WorleyParsons Komex

Re: Review of Olin First Quarter 2006 Groundwater Monitoring Report.

On behalf of the City of Morgan Hill (City), WorleyParsons Komex has reviewed the report by Olin Corporation (Olin) titled "First Quarter 2006 Groundwater Monitoring Report, Olin/Standard Fusee Site, 425 Tennant Avenue, Morgan Hill, California" (the Report). Our review focused on the components of the report related to the northeast flow situation wherein perchlorate from the Olin/Standard Fusee site (the Site) has impacted the municipal water supply of the City of Morgan Hill ("City"). Our review does not reference the various other potential perchlorate sources which at this time have not been shown to either exist, impact groundwater (in particular the Deep Aquifer), or impact any well operated by the City. In particular we reviewed in detail Appendix E, Northeast Groundwater Flow Assessment – Update (Appendix E). The main findings of our review are discussed below. For reader convenience, cited figures from the Report are included in **Attachment A** of this document.

FIGURE
E3

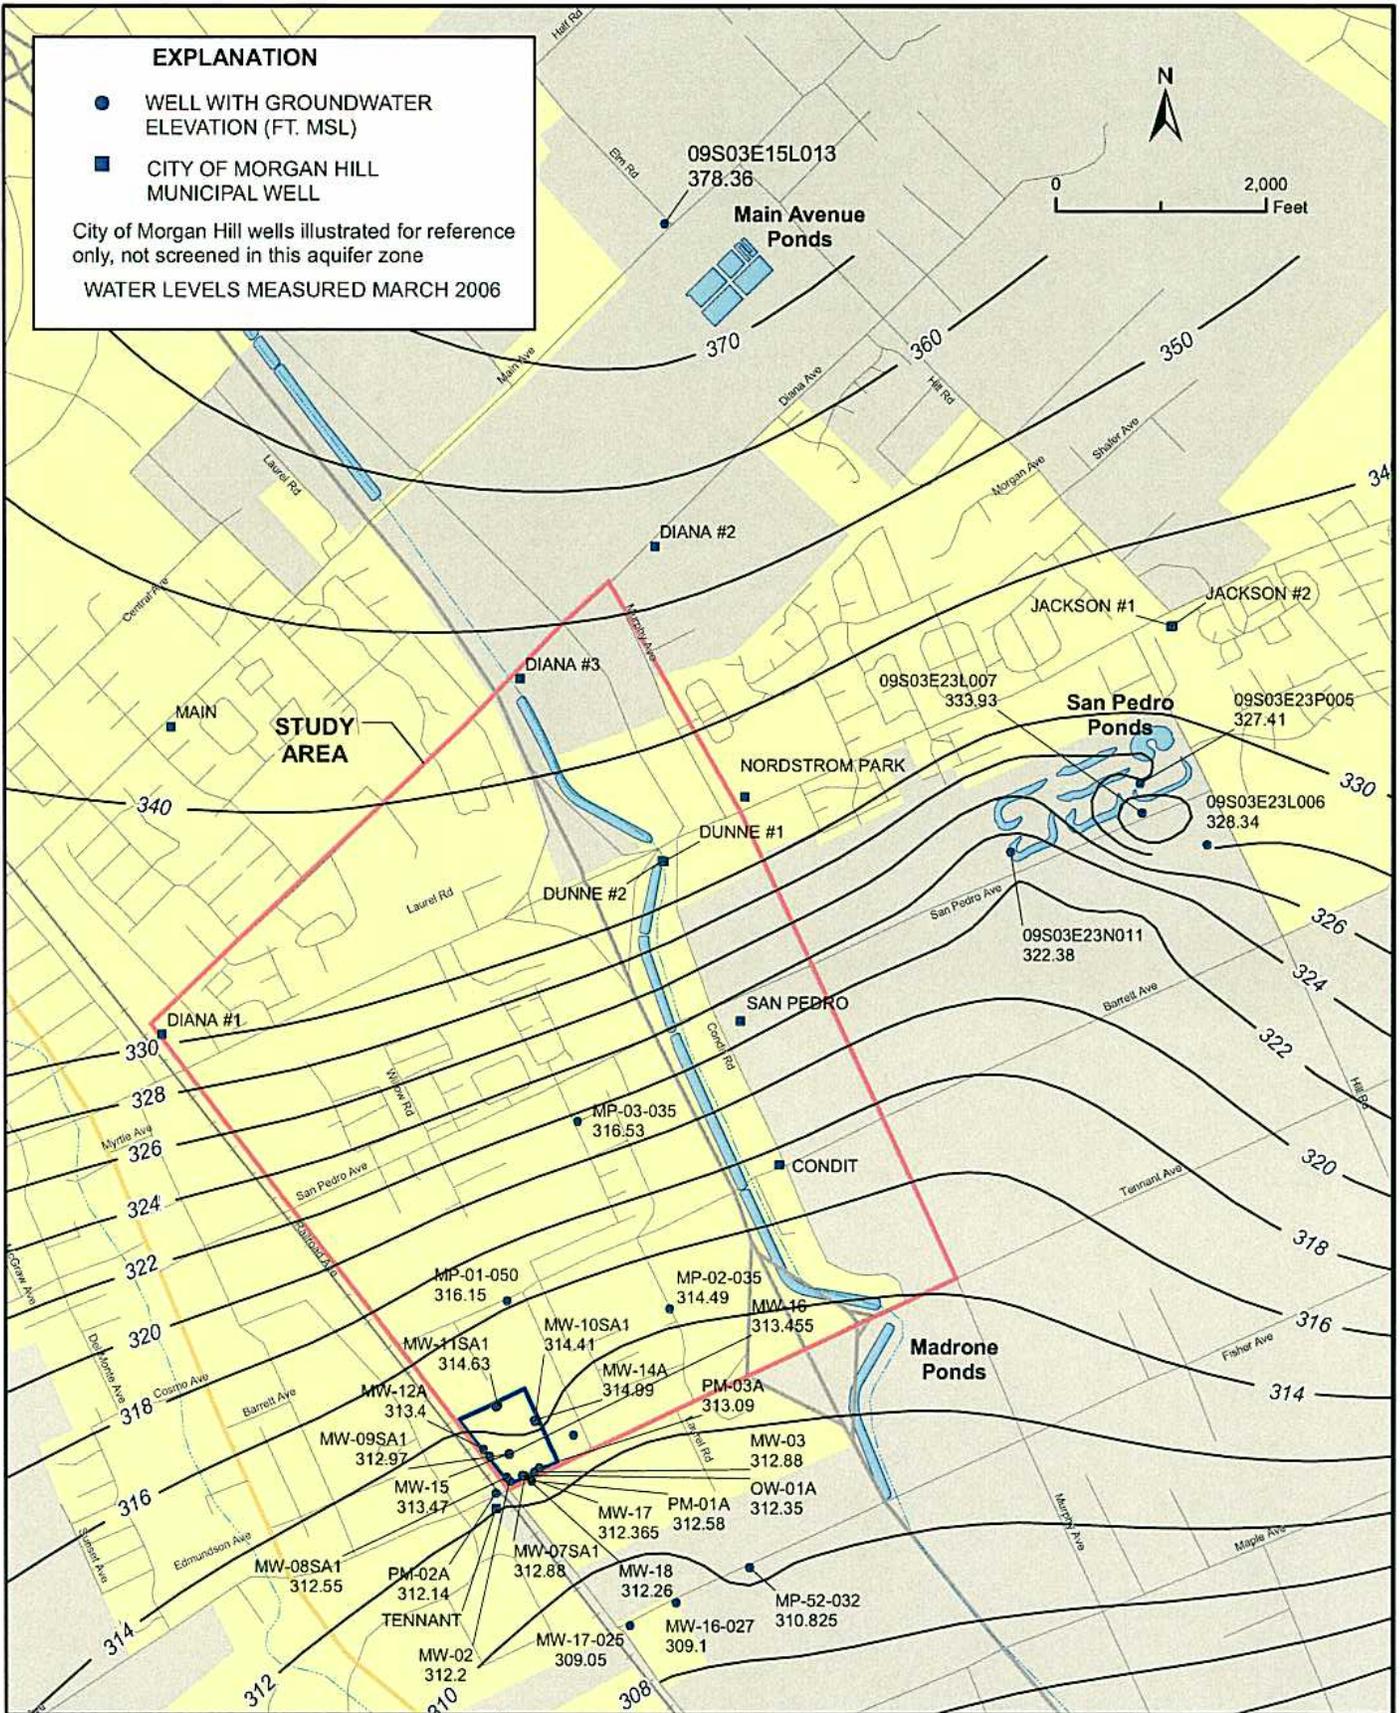
- f) Olin states that "Groundwater mounding is apparent beneath the San Pedro ponds...." (Report, Page E-4). However, clear evidence of mounding is not presented in the report. The Olin statement appears to be based on Figure E3, which shows groundwater levels in the Shallow Aquifer Zone in March 2006. This Figure shows one well near the San Pedro Ponds

with an abnormally high groundwater level (09S03E23L007, 333.93 ft MSL), whereas other wells equally near the ponds show no evidence of mounding at all (i.e, 09S03E23L006, 328.34 ft MSL; 09S03E23P005, 327.41 ft MSL; 09S03E23N011, 322.38 ft MSL).

FIGURE
E5a

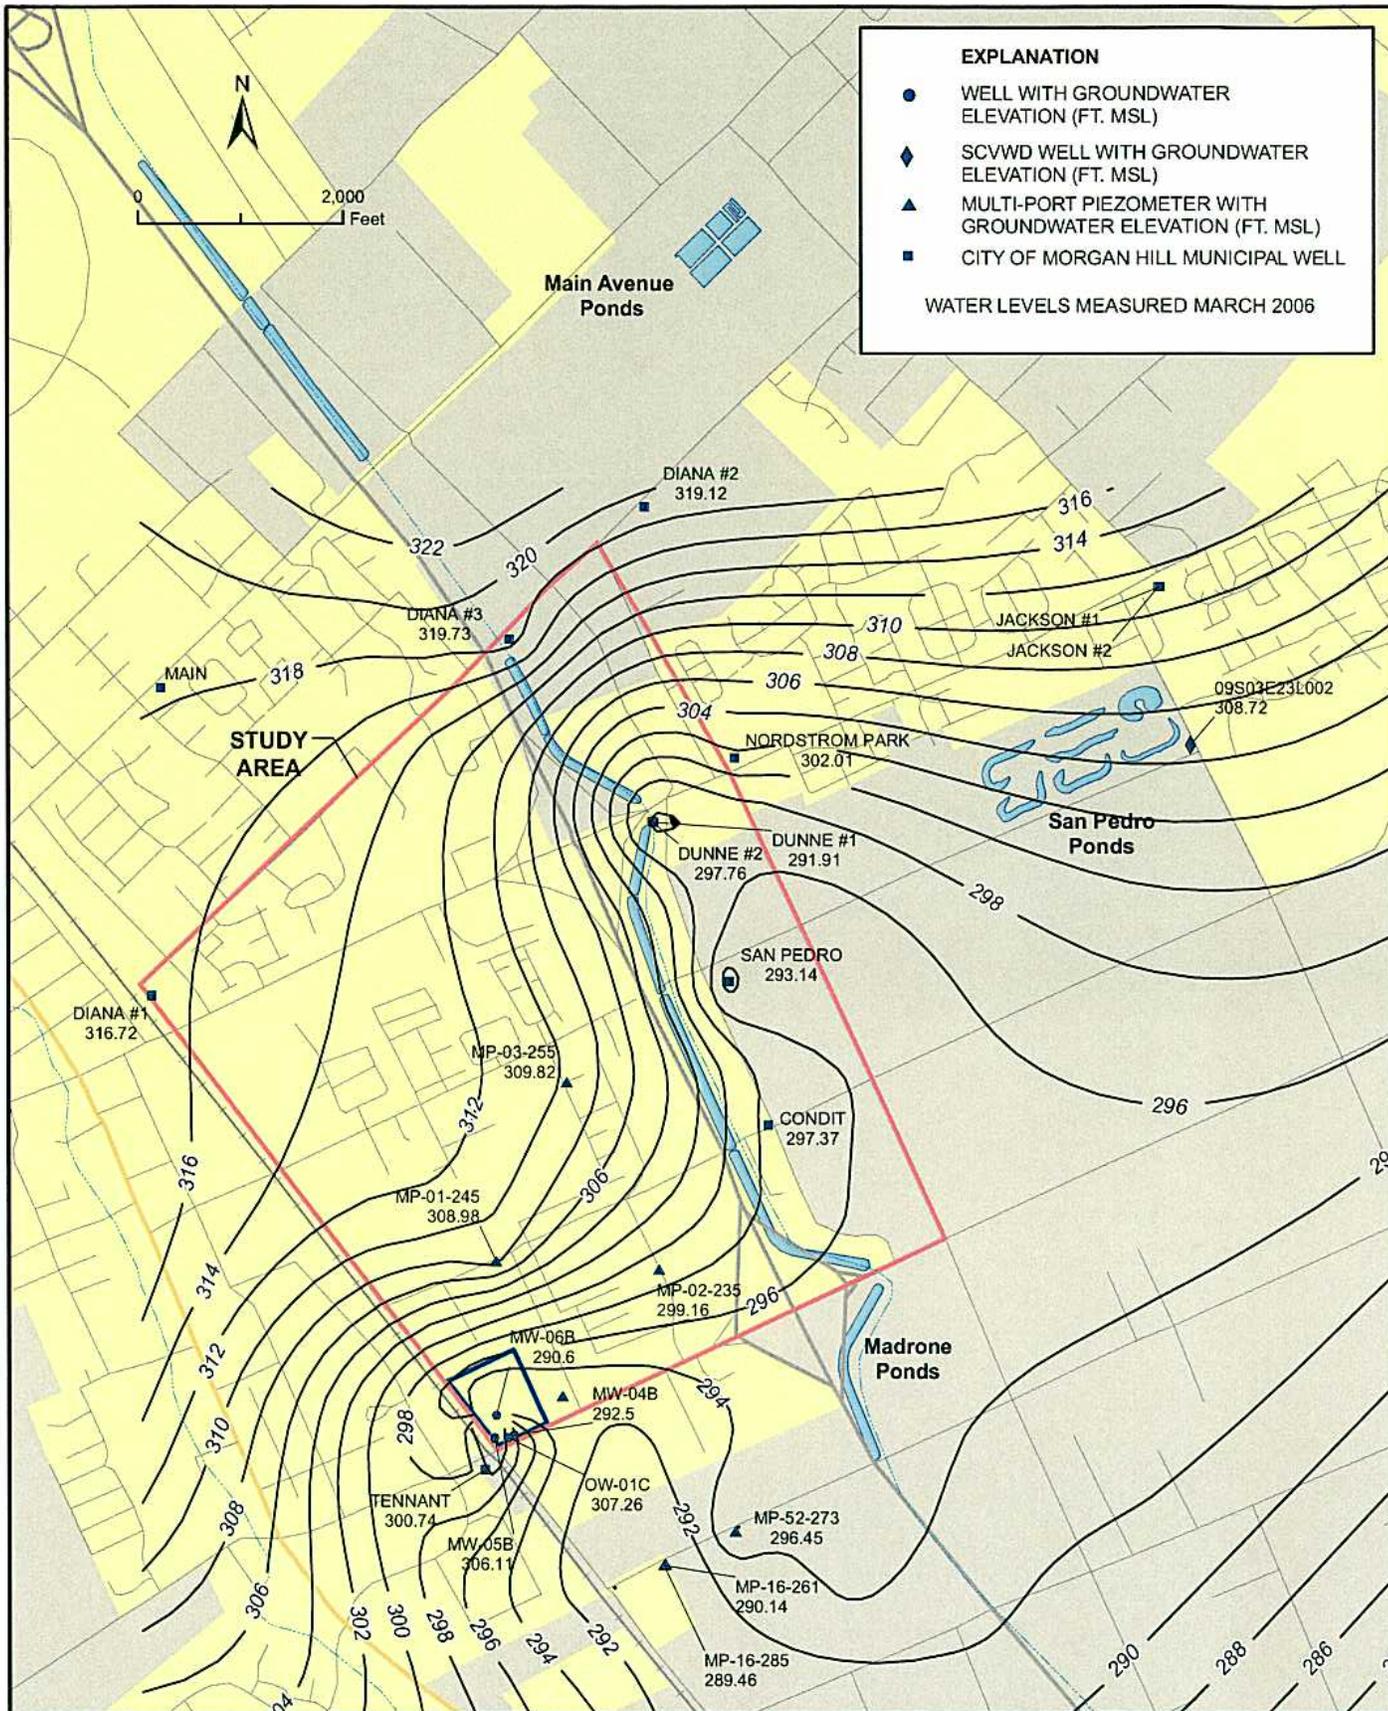
- In Figure E5b, piezometer PZ-03-325 (291.91 feet) is located between the 292 and 294 contour lines. It should be inside the 292 contour line.
- Multiport well MP-01-245 is mapped as an Upper Deep Zone monitoring point in Figure E5a. However, in Table E2a this multiport well is listed as being completed in the Lower Intermediate Zone, as is the deeper multiport well at this location, MP-01-262. It is not clear why this inappropriate data point is included in Figure E5a.

- Multiport MP-04 monitoring locations are not included on Figure E5a. Even though water elevations were not available for these wells, the well locations should be identified in relation to the other wells.

FIGURE
E5c

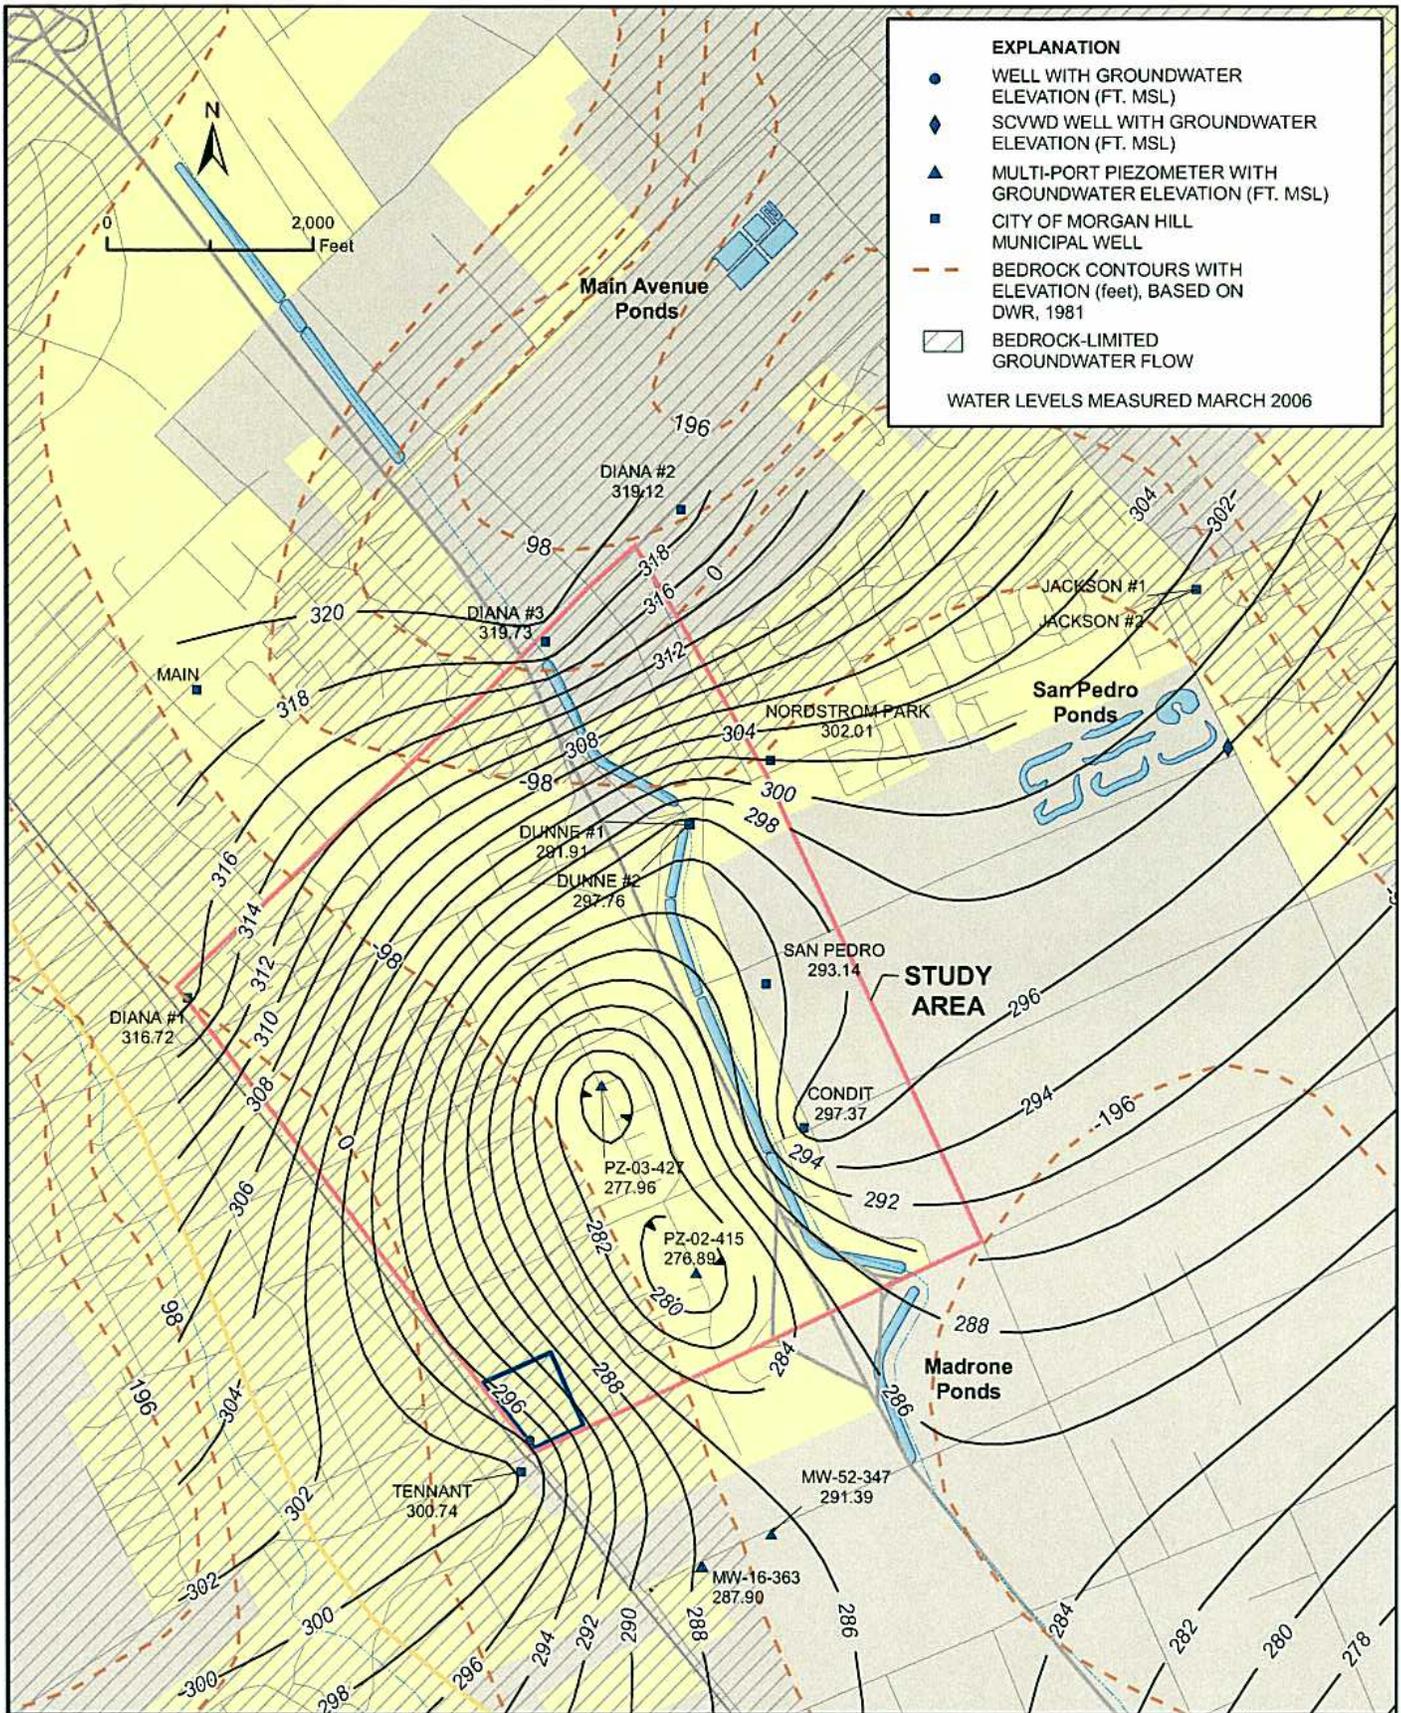
- e) The Lower Deep Aquifer Zone, now with more monitoring points (wells MW-16-363 and MW-52-347) shows a steep northeast gradient from the Site, during a period of little City pumping (Figure E5c). Since the City's wells largely penetrate to this zone, the Lower Deep Aquifer Zone must also be considered as a potential conduit for migration of perchlorate from the Olin site to the City's wells.

FIGURE
E19

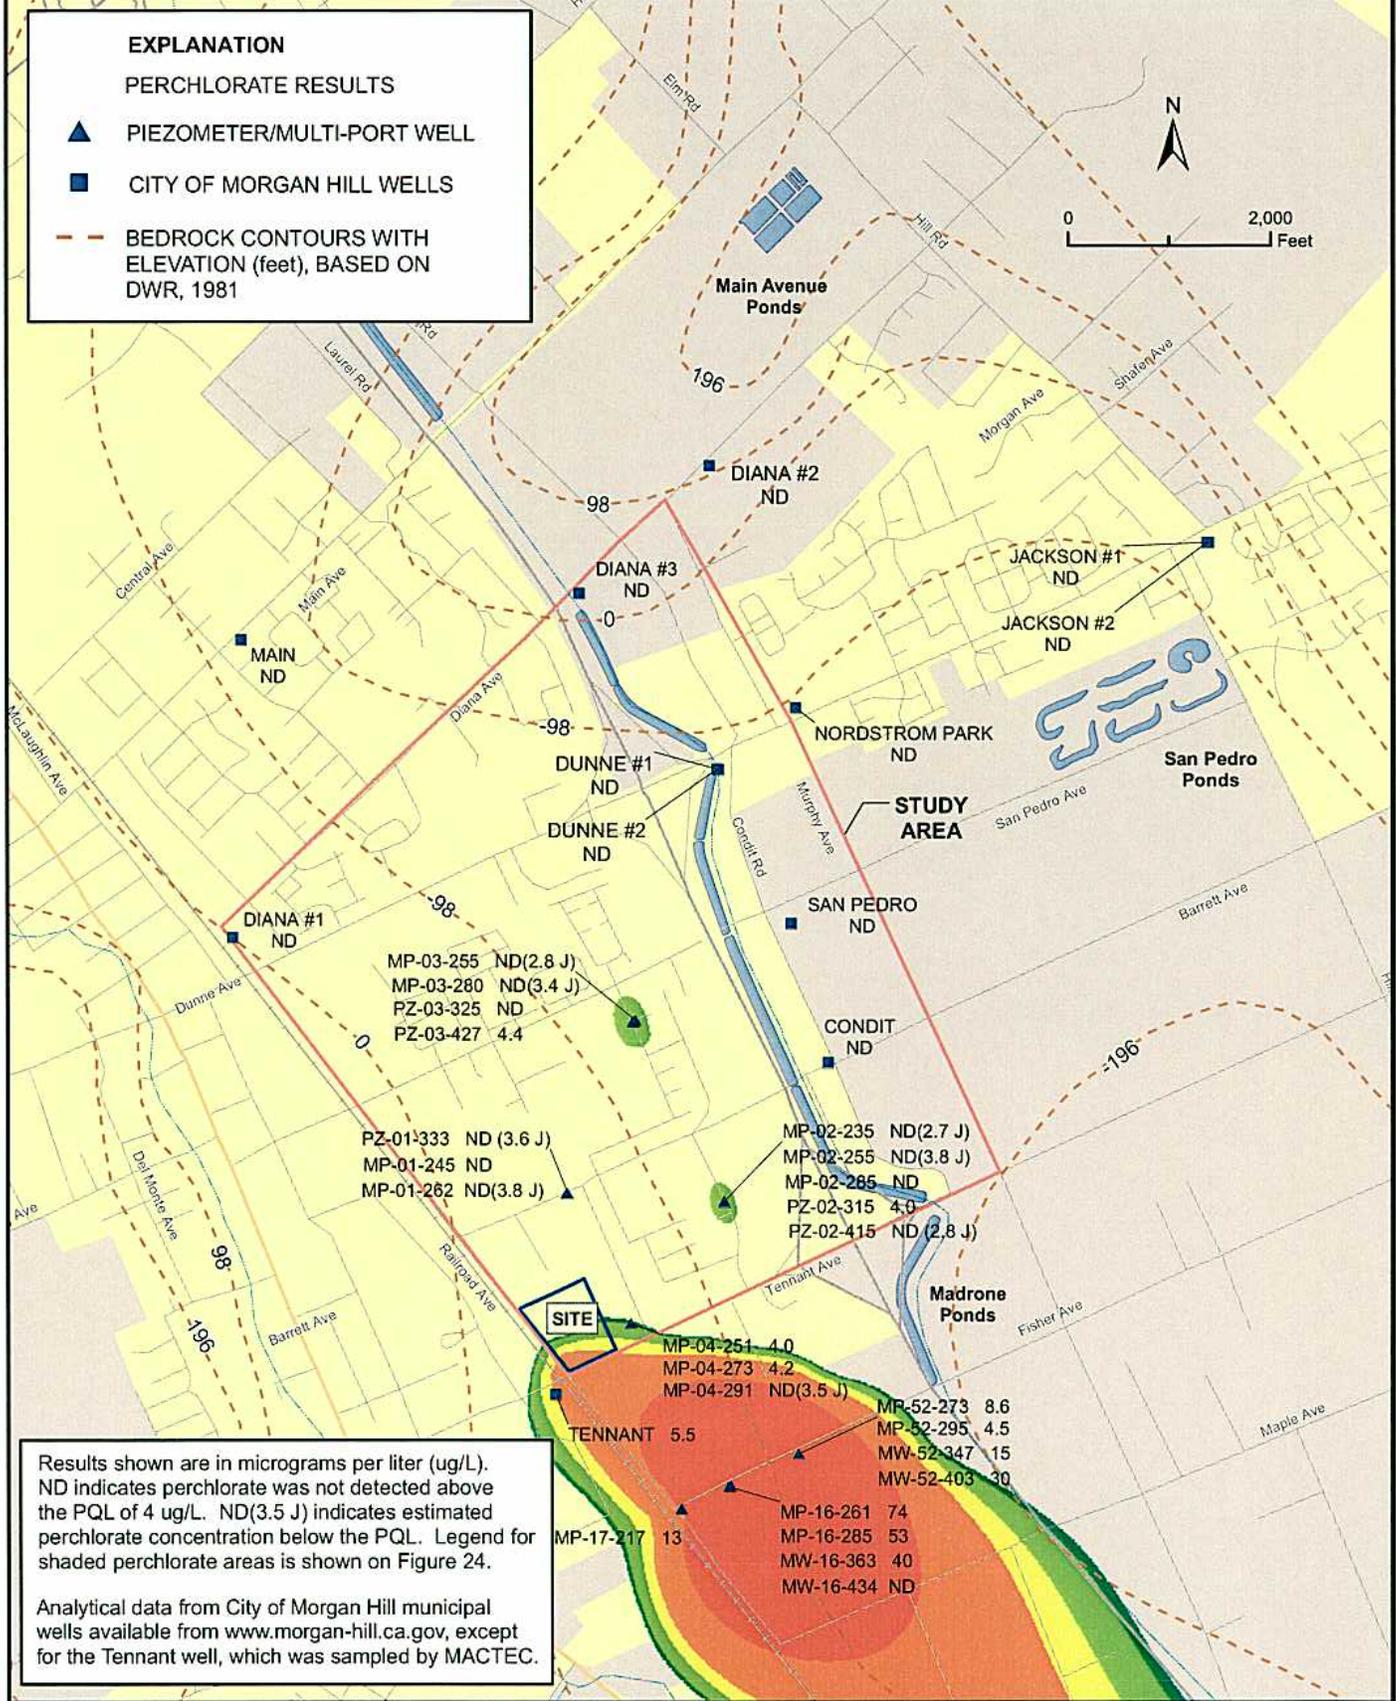
- a) Perchlorate was detected at, or above 4 micrograms per liter (ug/L) in the Deep Aquifer Zone in the following four wells (Figure E19): MP-04-251 (4.0 ug/L), MP-04-273 (4.2 ug/L), PZ-02-315 (4.0 ug/L) and PZ-03-427 (4.4 ug/L). The plume of perchlorate in Deep Aquifer Zone groundwater to the northeast of the Olin Site has not been delineated to the north, northeast, or northwest of the present detections of perchlorate.
